Access Compliance Report Public Rights-of-Way (Curb Ramps)

Main Street: SILVERWOOD_DR Cross Street: BASKERVILLE_RD Location: N

ADA ID: RPAT211202122233 Ramp Type: Type 1 - Perpendicular Diagonal Initial Pass/Fail: Pass Overall Compliance: No Severity Score: 16

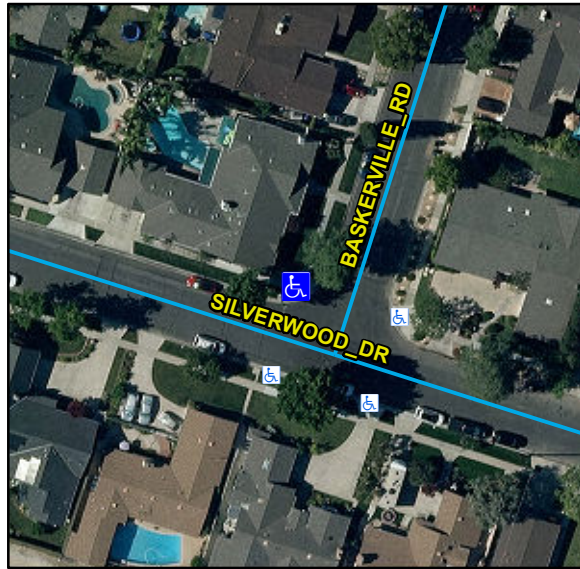
Remove & Replace Curb Ramp With Two New Directional Ramps or Equivalent. Gutter Ponding Observed.

Possible Solutions:
